## Appendix D

### Responses to Data Requests

In the Matter of the Application of Snowshoe BESS, LLC for a Site Permit for the up to 150 MW Snowshoe Energy Storage Project in Olmsted County, Minnesota

PUC Docket No. IP-7138/ESS-24-270

OVERALL SEEDING  
EXHIBIT

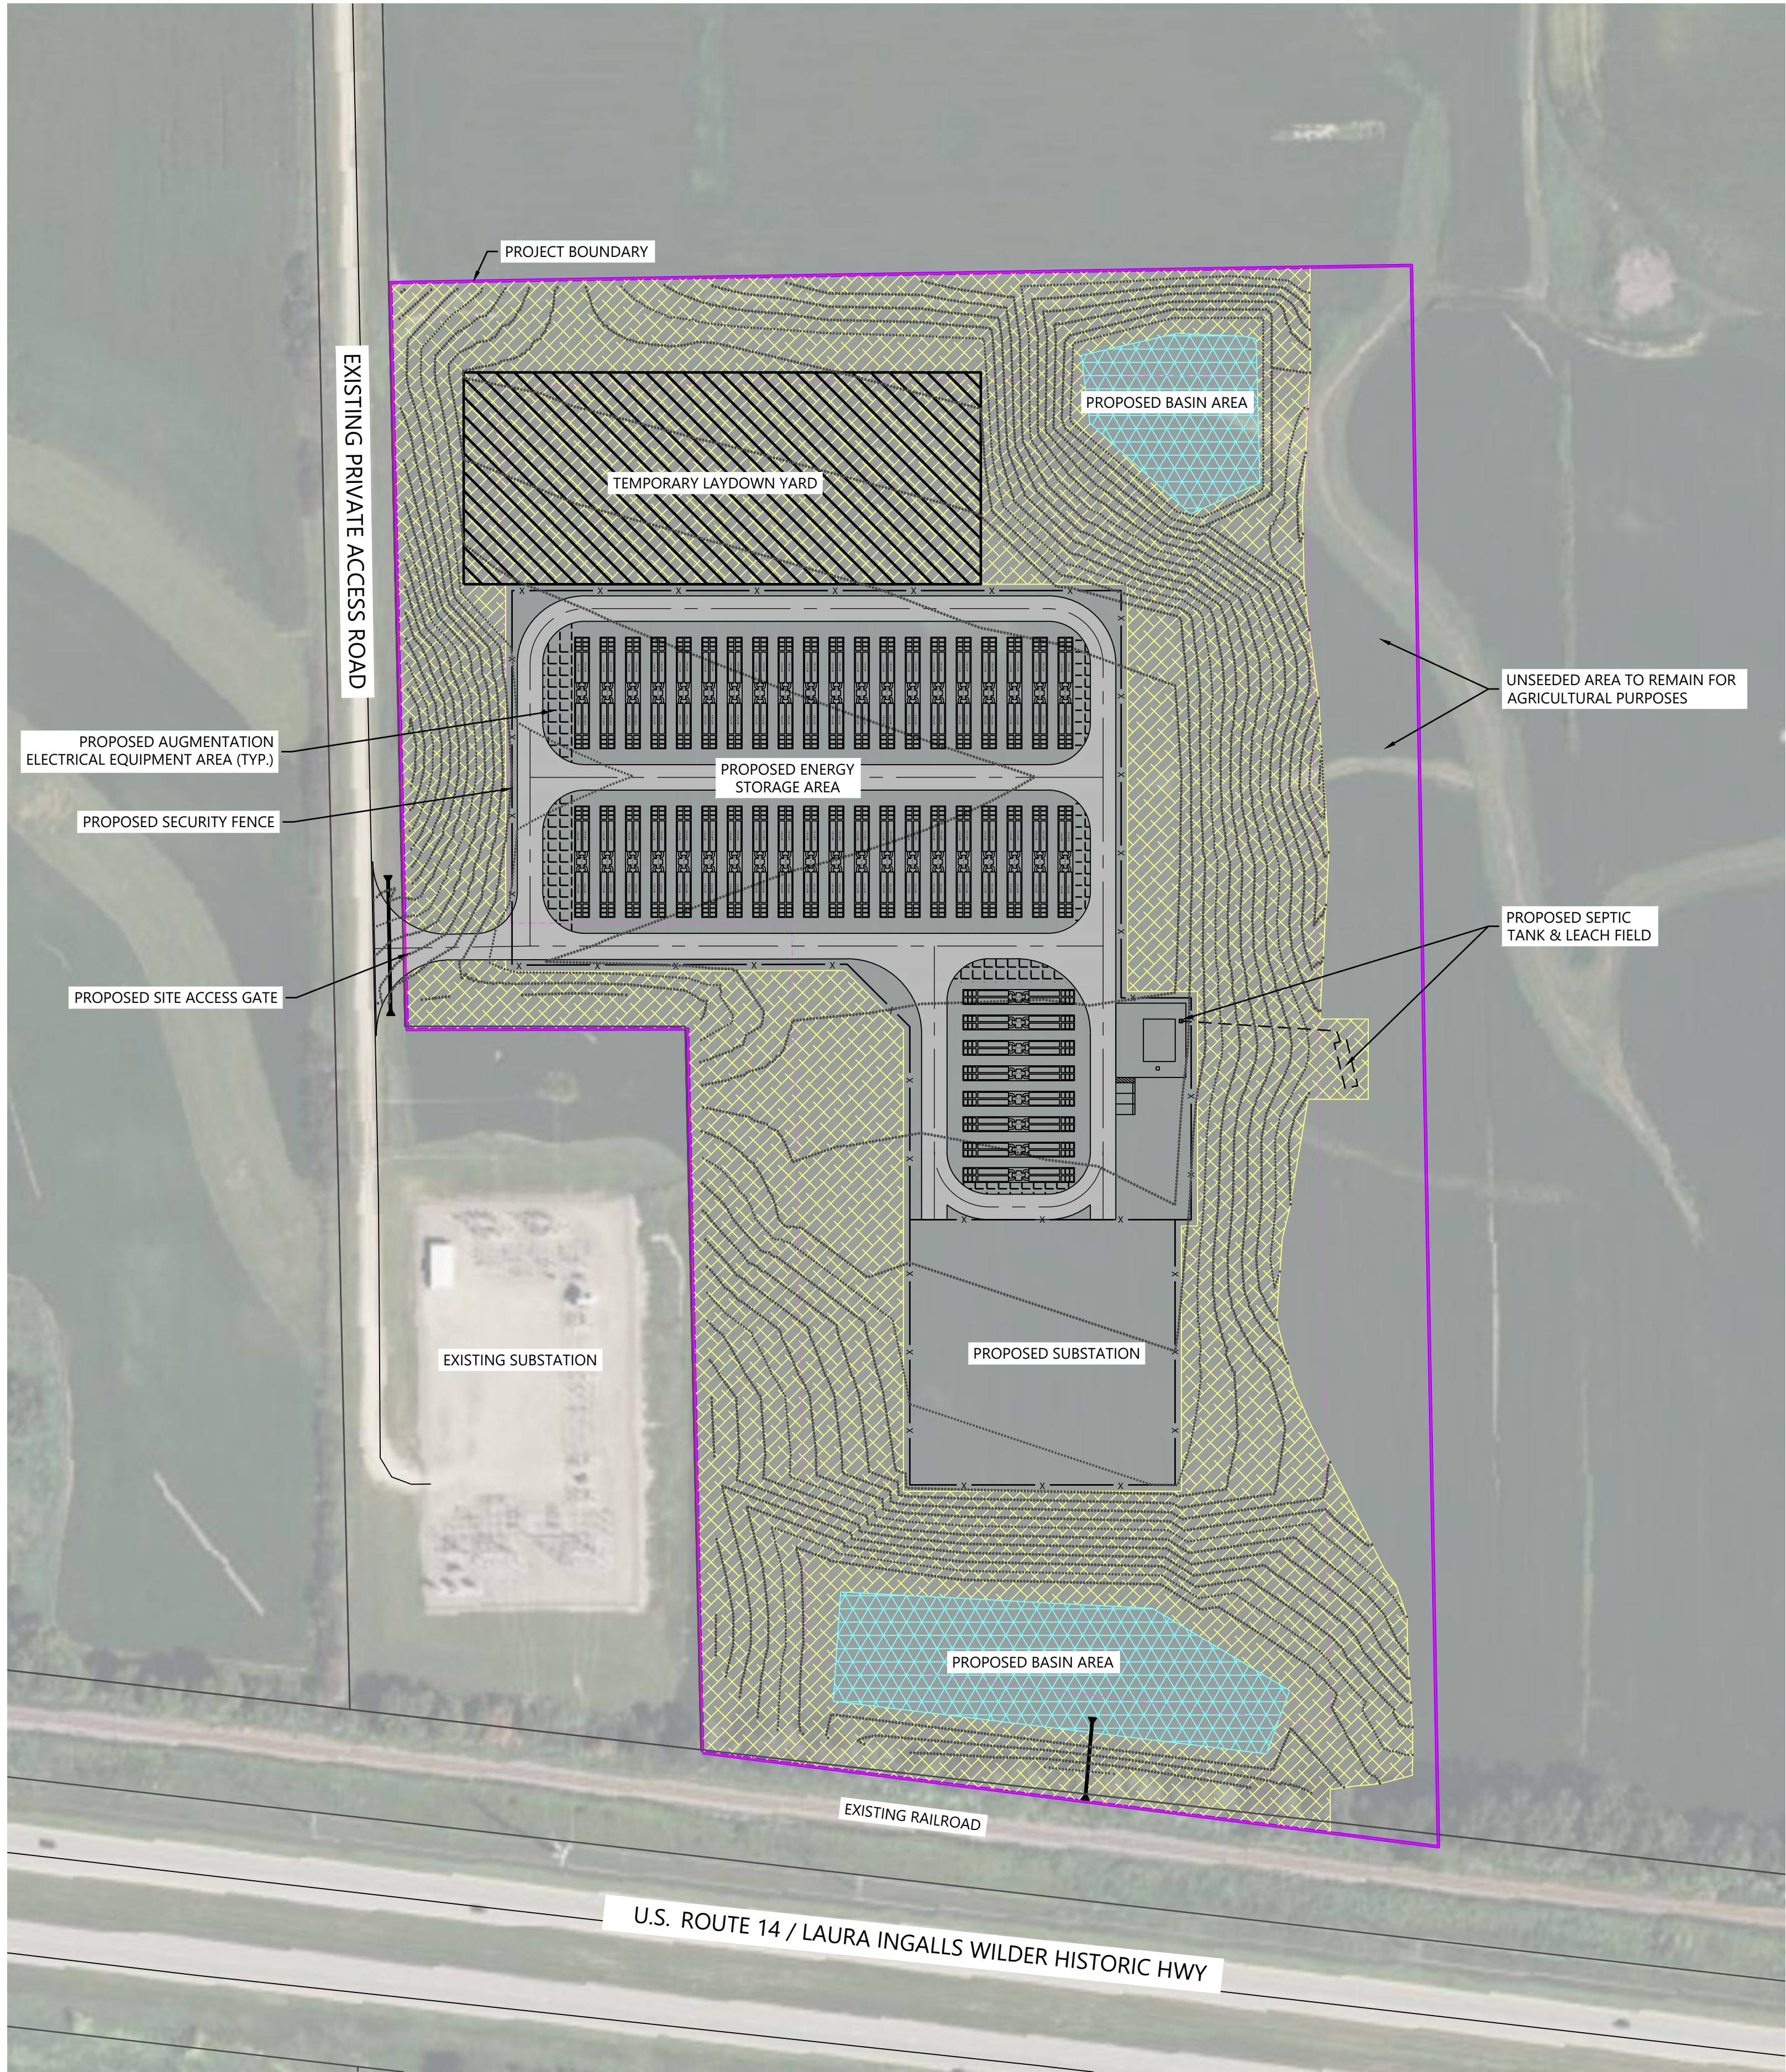
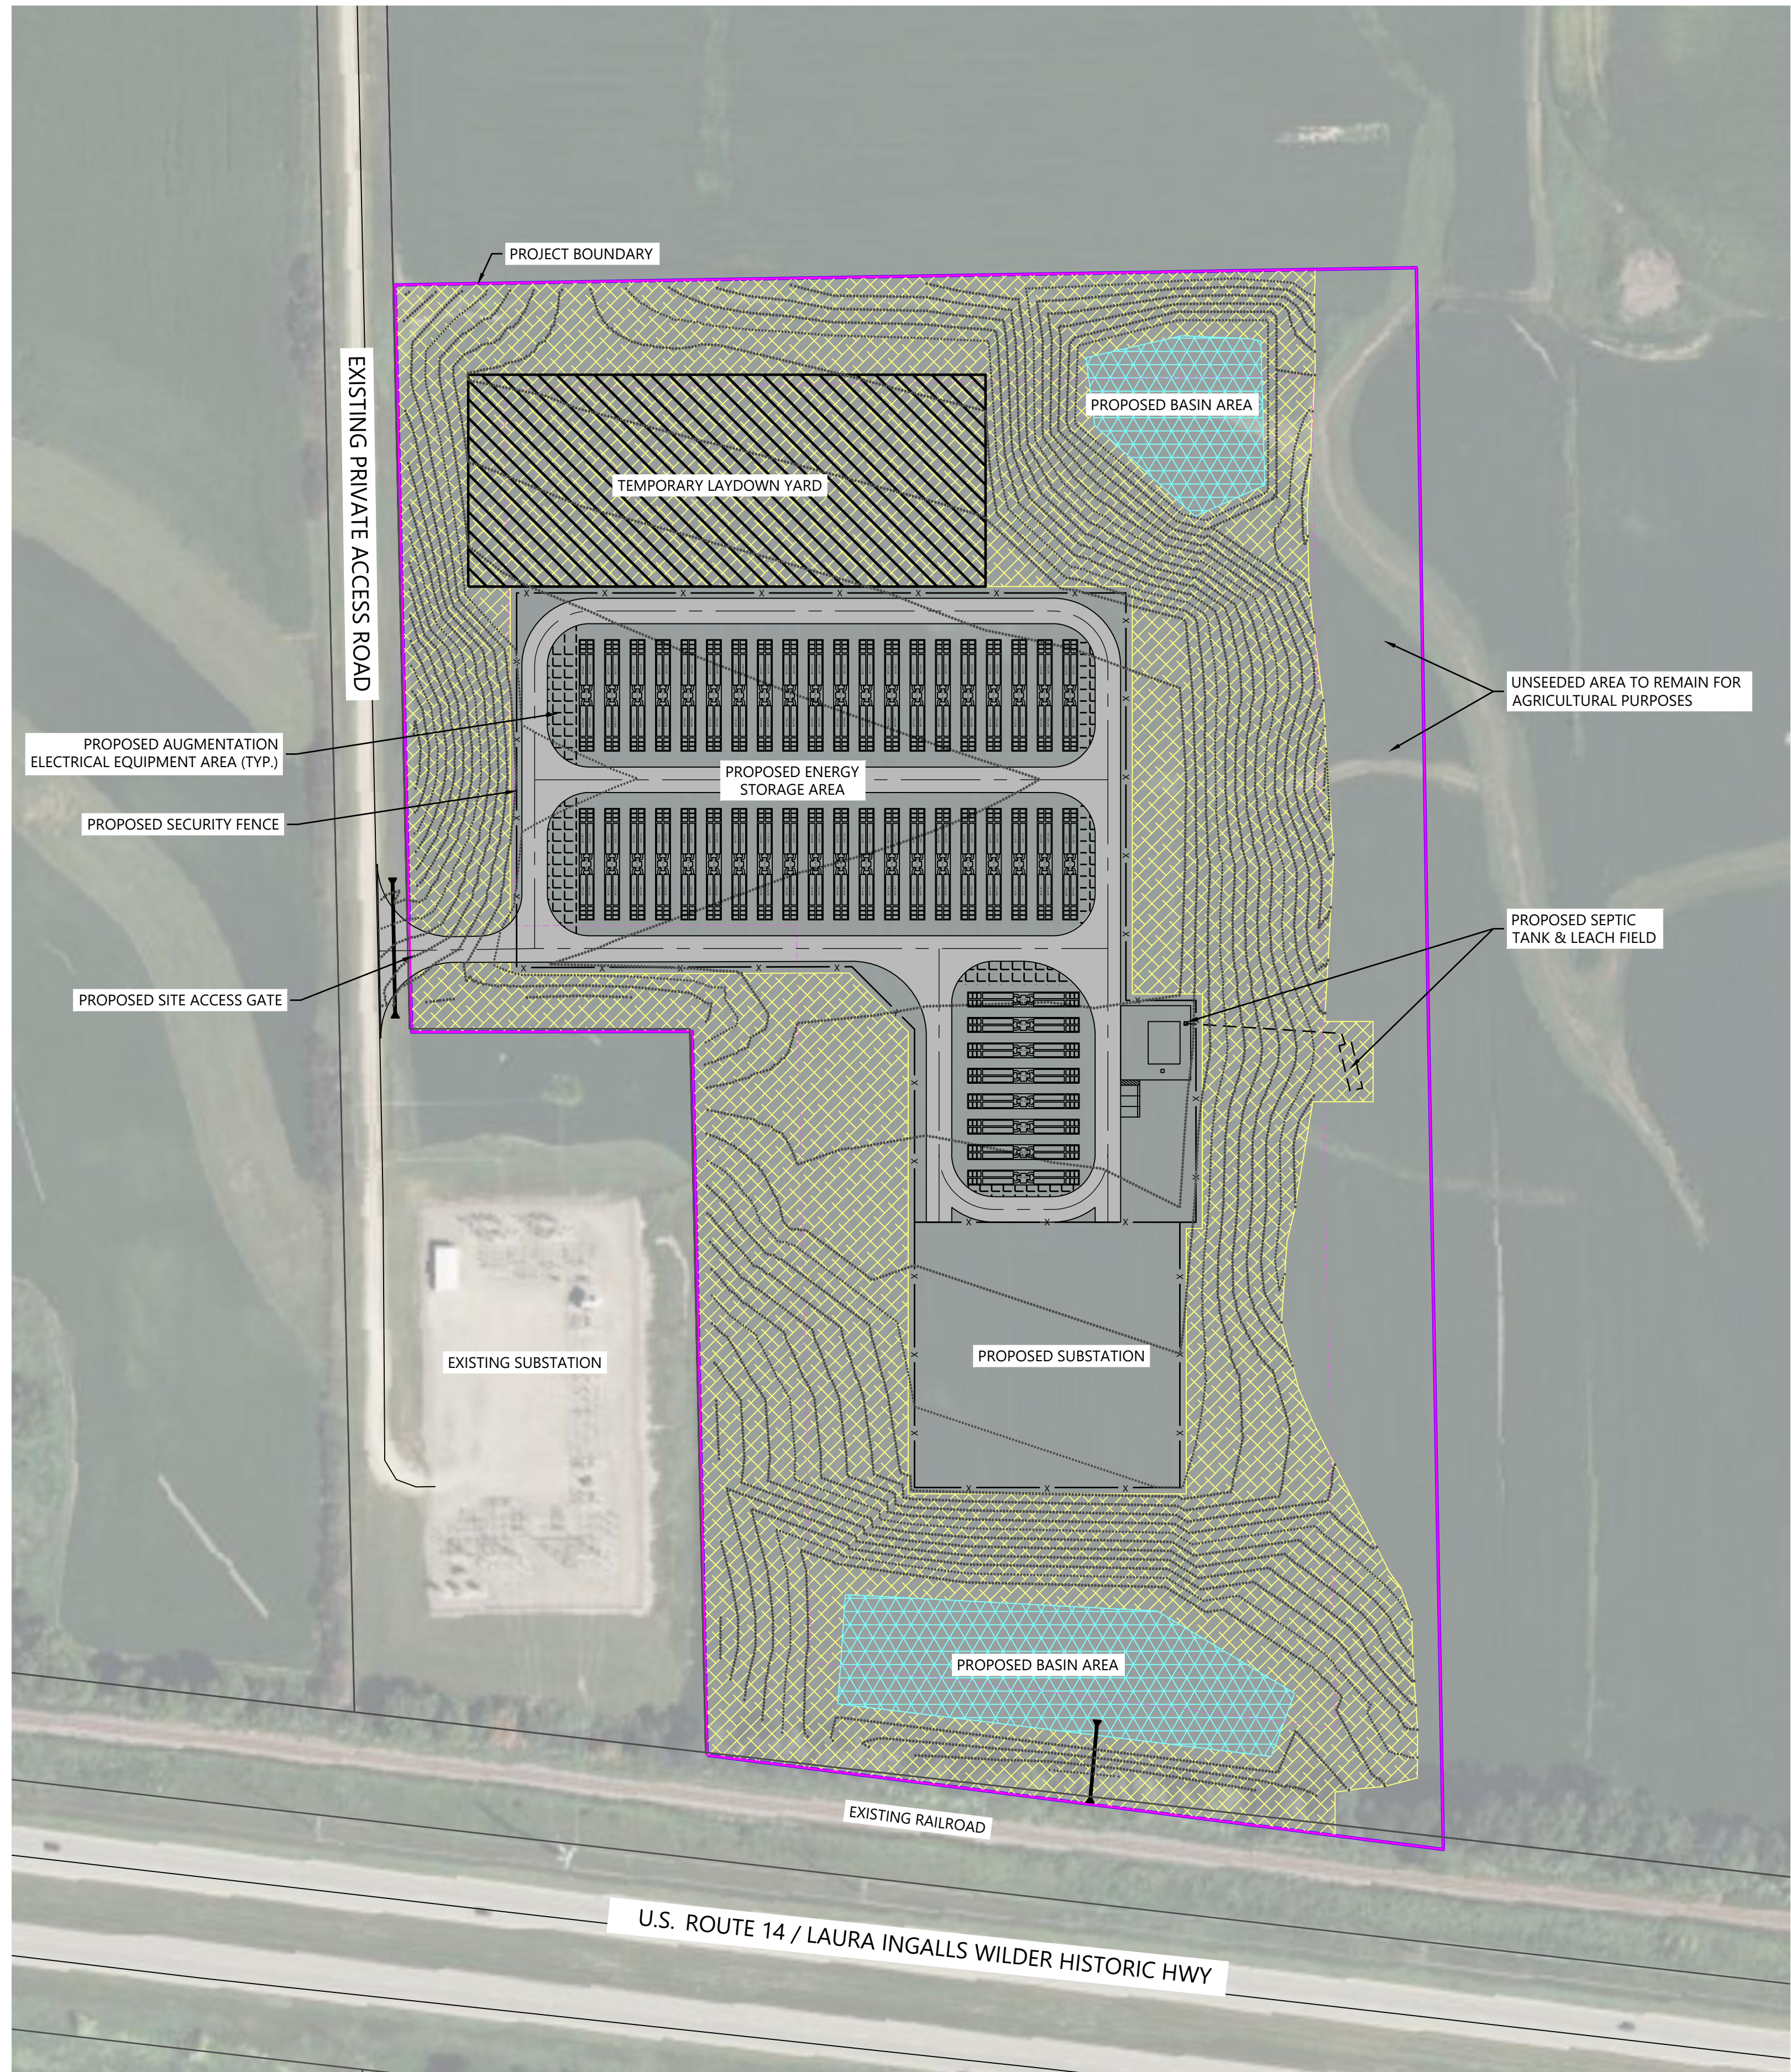
- a. A description of the areas that will be fenced. Figure 2 of the site permit indicates security fencing around BESS facility and substation, while the Overall Seeding exhibit included in the draft Vegetation Management Plan Project shows a larger fenced area that includes the stormwater basins and potentially some areas that may be farmed.

The discussion of site restoration in Section 4.3.3 of the application and in the vegetation management plan indicate that the restoration will include a mix of re-seeding with an open space seed mix (MnDOT Mesic Inslope Mix) and return to agricultural use in some areas. The Overall Seeding Exhibit in the vegetation management plan indicates an irregularly shaped prairie seeding area within the fence line on the eastern portion of the site that borders an area described as “unseeded area to remain for agricultural purposes.”

- a. Discuss the rationale between reseeding only a portion of the site while maintaining agricultural uses within the fenced area.

- b. Discuss what types of agricultural uses are contemplated within the fence line, and how that area can be accessed. The seeding exhibit indicates only one gate at the main entrance.

- c. Please explain how the boundary between the prairie and agricultural area will be maintained and how the different uses (prairie and agricultural purpose) can occur within the fenced area.

There was an erroneous label (i.e., Proposed Security Fence) pointing to the Project Boundary that required updating on the VMP seeding exhibit to remove this label, please see updated exhibit attached. The plan legend correctly shows the fenced area where the proposed security fence line surrounds the proposed equipment, but there is no proposed vegetation within the project fence. The groundcover within the BESS yard shall be gravel. The remaining area within the Project Boundary, but outside of the fenced area will be either be seeded, as shown in the Seeding Exhibit attached to the VMP, or allowed to remain in agricultural uses.

See above. There is no proposed agricultural use within proposed security fence.

The seeding limit shown on the plan is primarily driven by site grading to establish vegetation on slopes to reduce erosion across the Project site. The portions of the Project site along the eastern edge of the Project Boundary that have previously been used for agriculture, and are unused by the Project, will continue to remain in agriculture or as otherwise directed by the landowner. The seeded areas will be maintained per the Vegetation Management Plan (VMP). Additionally, please see responses to 6.a. and 6.b above.

Receptor Identifications - Response to DR-8

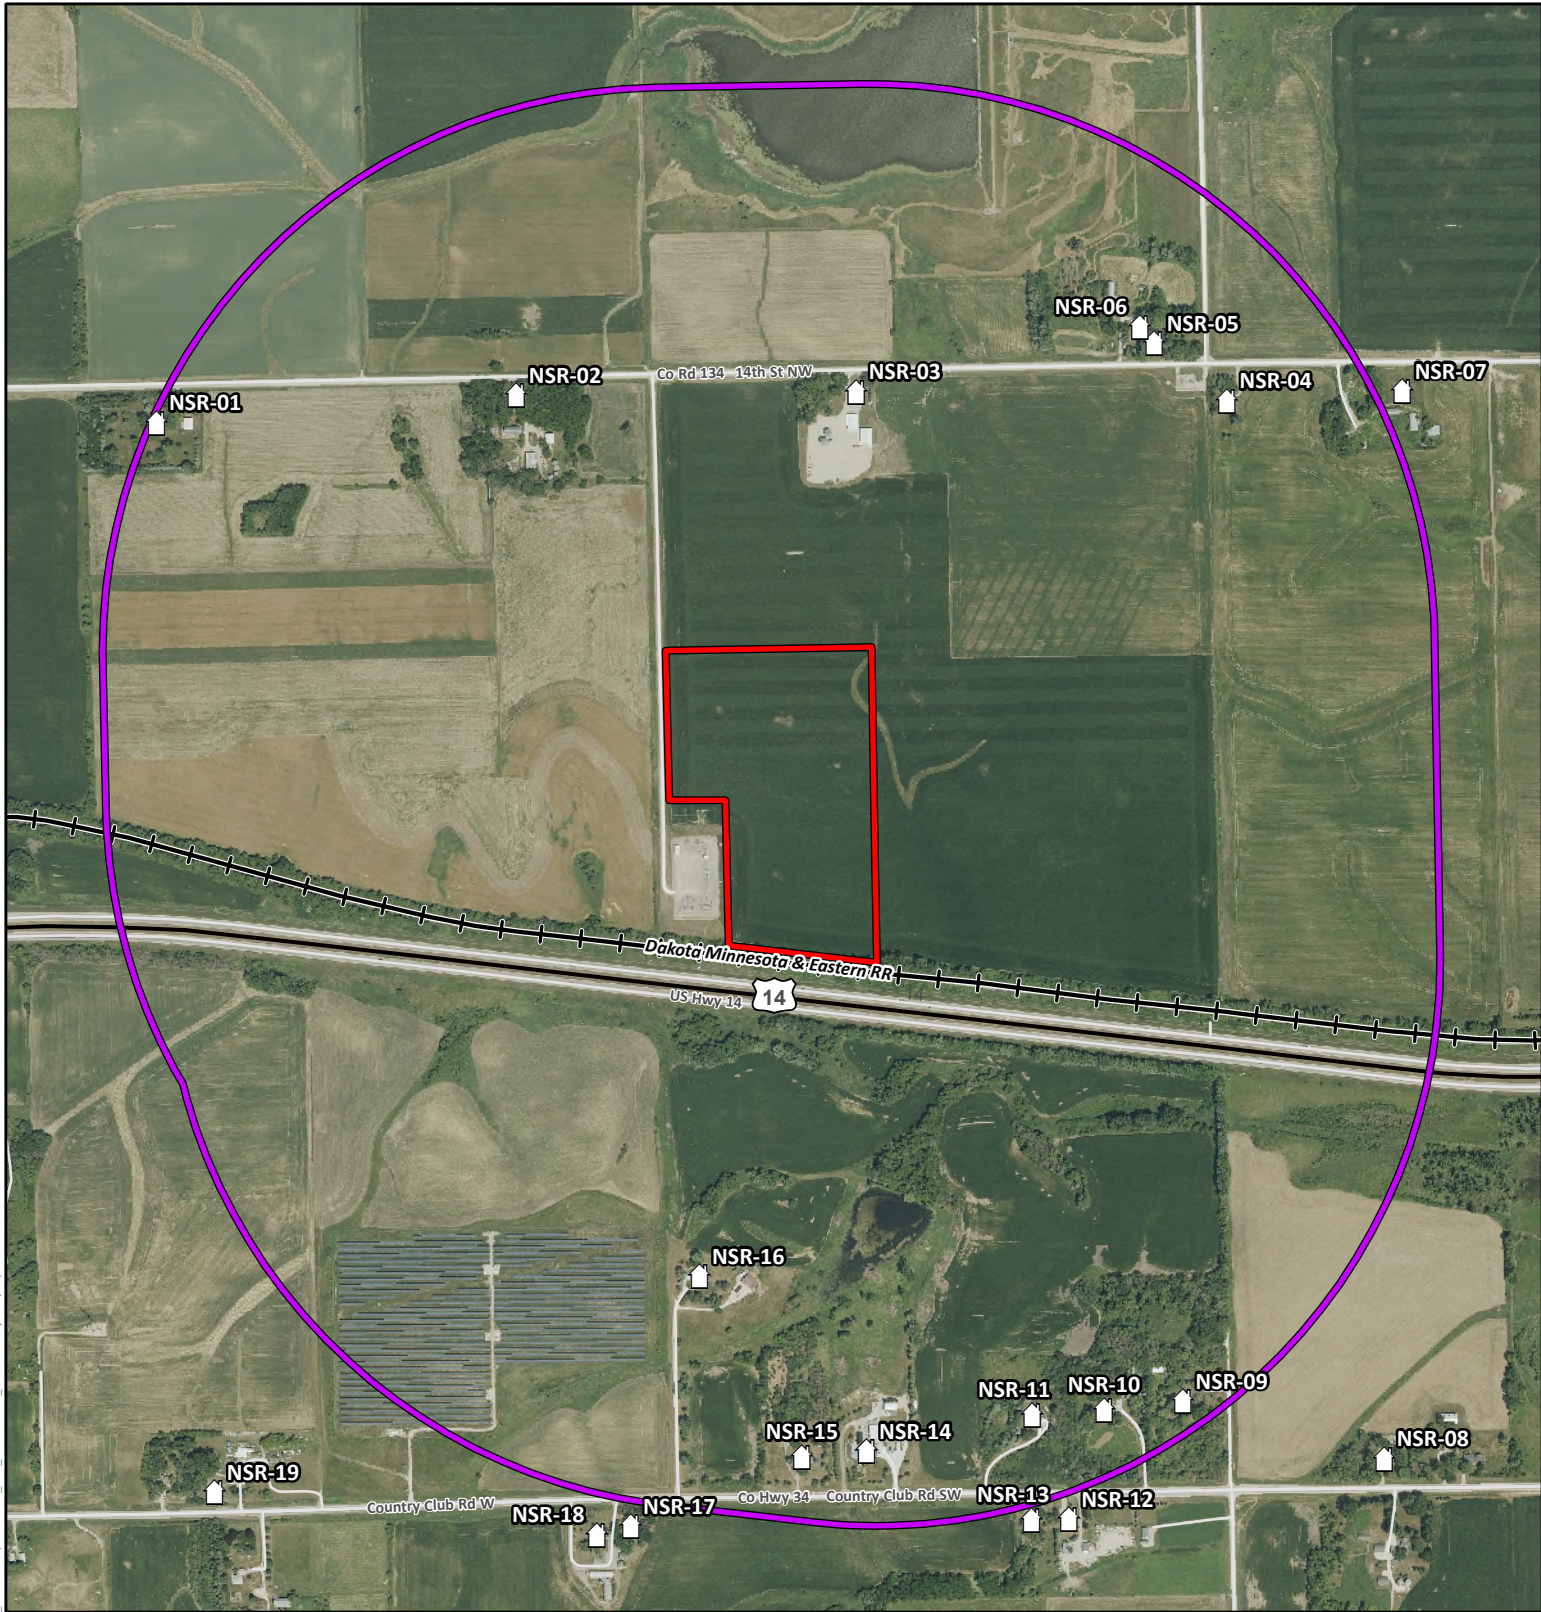
- b. Please provide a map indicating the receptor ids for the 19 nearby residences.  
Please see receptor ID map attached (Exhibit 1 – Receptor Identifications).
